This gallery shows some pictures of bad solderings - they should prevent you from making the same errors (feel free to add even more pictures here!)

<http://wiki.midibox.org/> - **MIDIbox**

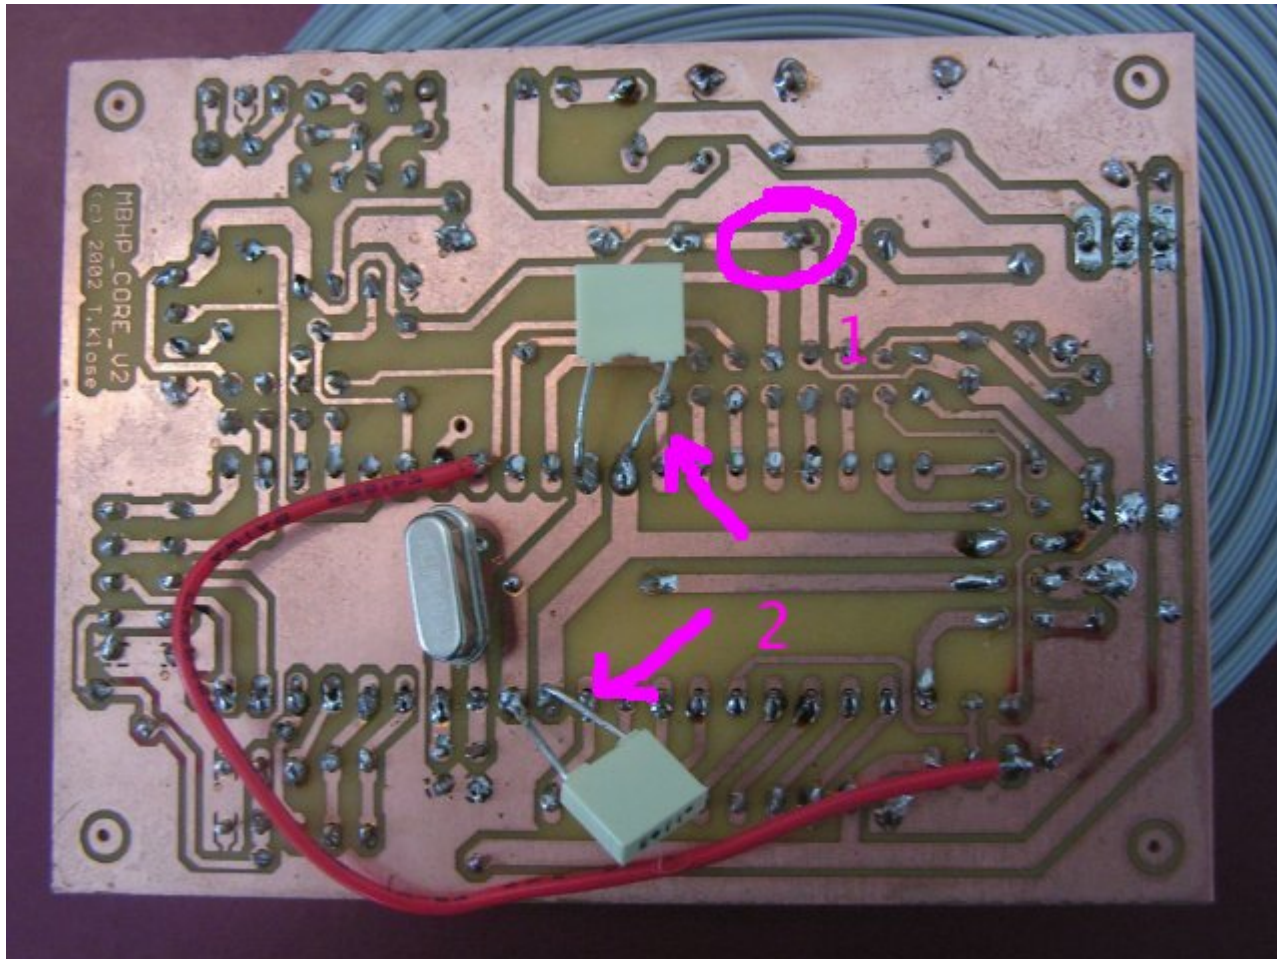
1: The core module has some badly soldered connections(loose), which could lead to failures. There are also missing solderings (e.g. 33pF cap below crystal). It makes sense to solder each pad again, the [Soldering](#) guide in the Wiki gives some useful tips

2: The legs of the caps should be cut, otherwise they can cause a short circuit which can damage the PIC!

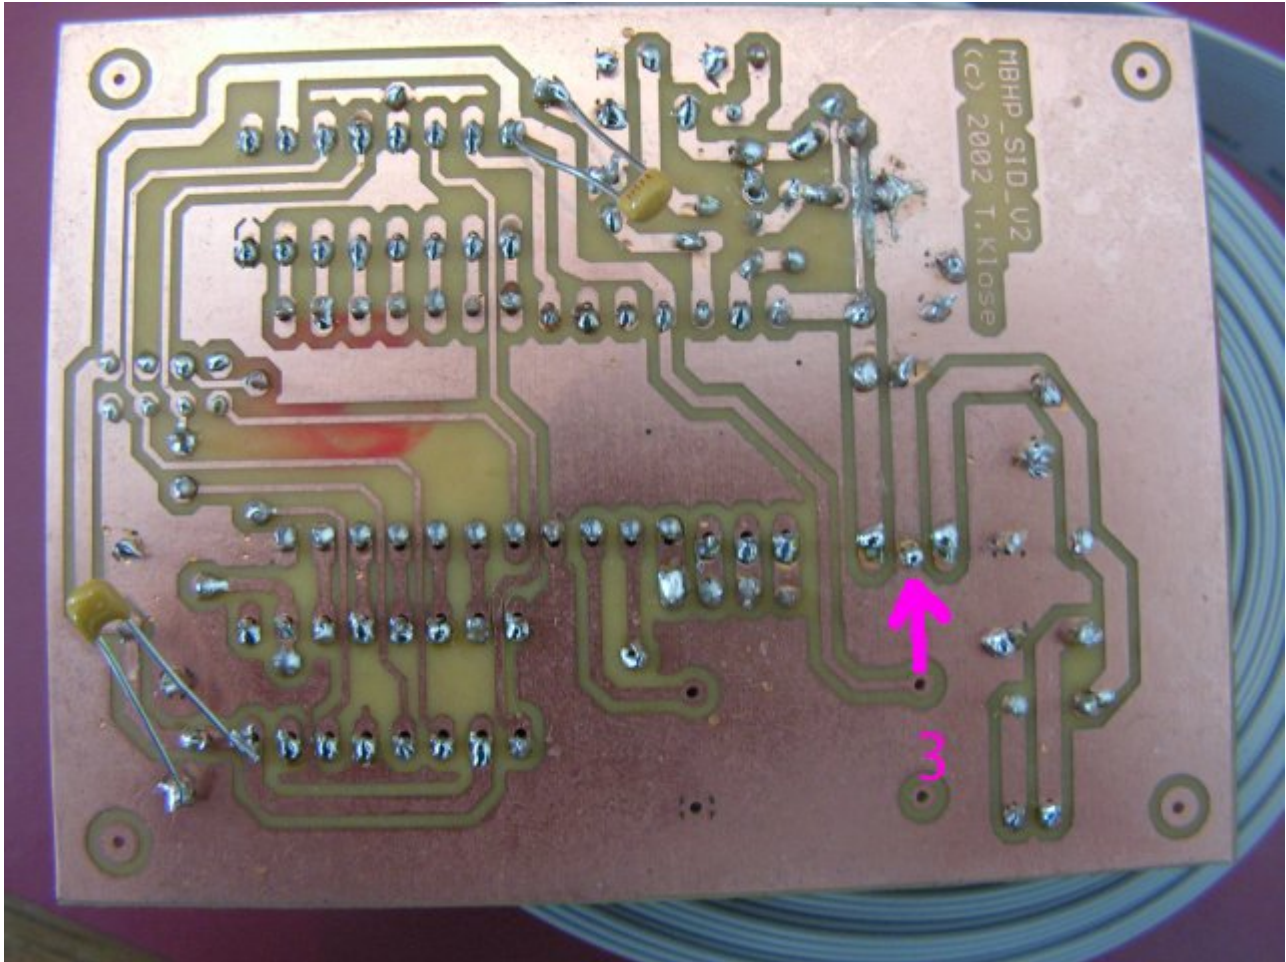
3: This seems to be a bad ground connection directly at the 78xx - it can lead to the wrong voltage. Here the same: just solder the pads again, it will help  
And same as above: the long cap legs need to be cut, the danger of shorting out is too high!
